Economic Commission for Europe**Inland Transport Committee****World Forum for Harmonization of Vehicle Regulations****158th session**

**1958 Agreement – Consideration of draft amendments
to existing Regulations submitted by GRE****Proposal for Supplement 4 to the 01 series of amendments to
Regulation No. 112 (Headlamps emitting an asymmetrical
passing beam)****Submitted by the Working Party on Lighting and Light-Signalling***

Figure 1

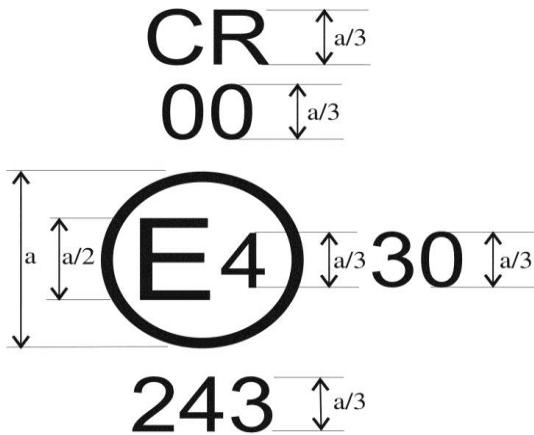
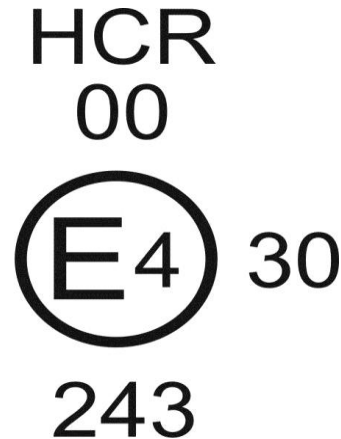
Annex 2, amend to read:

Examples of arrangement of approval marks

$a \geq 8$ mm (on glass)

$a \geq 5$ mm (on plastic material)
